USGS Suggestions for Hydrologic Monitoring of the CD-IV Geothermal Project

Figure 1. Locations of MCWD wells and existing and proposed geothermal wells.

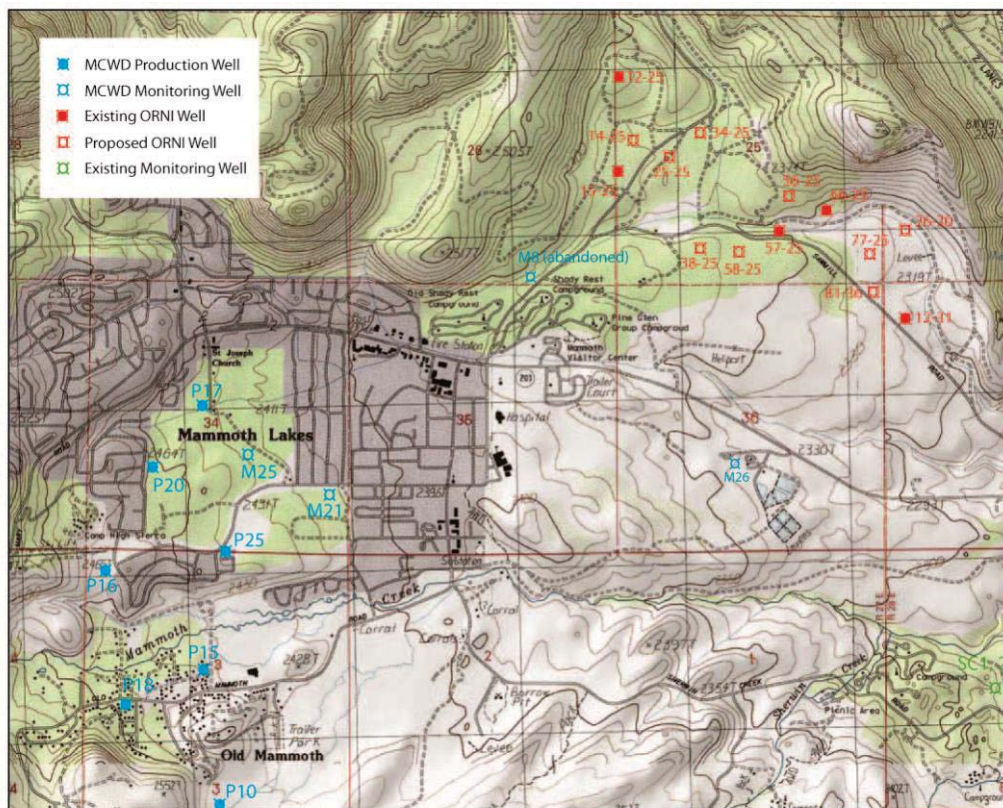
Information from MCWD monitoring well (M26), located near the water district office, indicates that warm (90° F / 32° C) water exists below a depth of 600' below land surface (BLS) at that location. Another, now abandoned, MCWD well (M8), which was located along the Sawmill Cutoff road, also encountered a cold and underlying warm interval. See Figure 1 for the locations M26 and M8.

The pressure record from the deep geothermal well, coupled with the pressure records of the nearby dual-piezometer well, would provide information needed to assess potential changes in the vertical hydraulic gradient at a location which is roughly midway between the geothermal production wells and existing MCWD supply wells. See Figure 1 showing the locations of MCWD wells and existing and proposed geothermal wells.

We suggest that the existing monitoring wells SC-1 and SC-2 (see Figure 1) be instrumented with submersible pressure/ temperature transducers to produce a ground-water record for the purpose of hydrographic control. These two wells are valuable because they have long-term water level records dating back to 1983 and they monitor two different pressure zones in the cold water aquifer system.

Figure 2. Map showing potential locations of proposed monitoring wells.

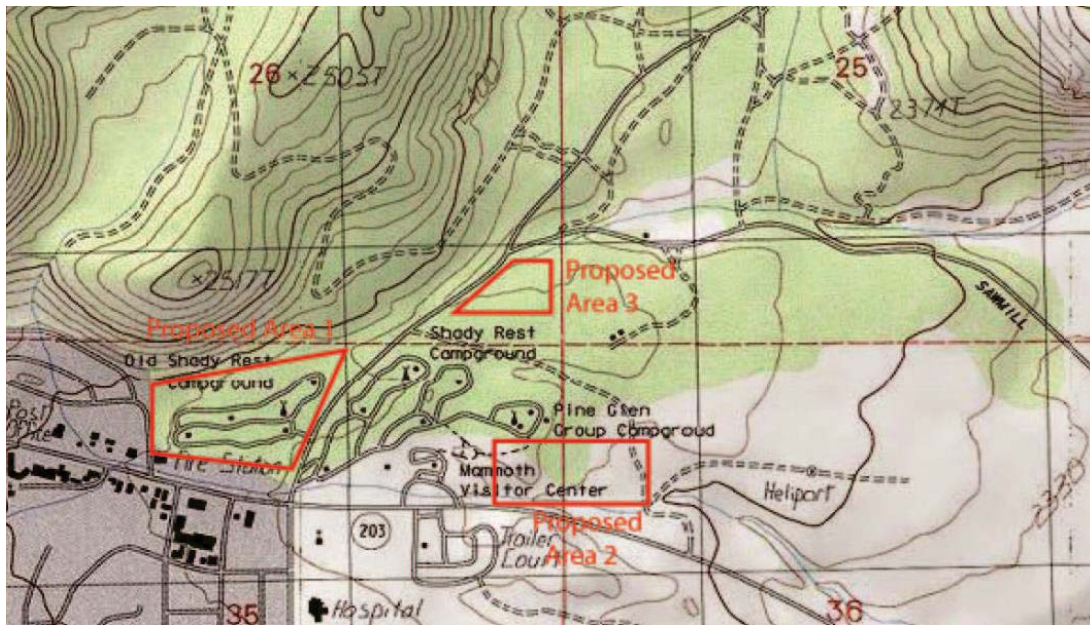
Potential locations for the two nearby monitoring wells are: (1) in the north-central part of Section 35 and northwest of the Hwy 203 / Sawmill Cutoff junction on USFS property in the vicinity of the Old Shady Rest Campground; (2) east-northeast of the Mammoth Visitor Center on USFS property near the USFS 'junk yard'; and (3) in the SE corner of Section 26, southeast of the intersection of the Sawmill Cutoff road and the road leading into Shady Rest Park. See Figure 2 showing proposed locations of monitoring wells.
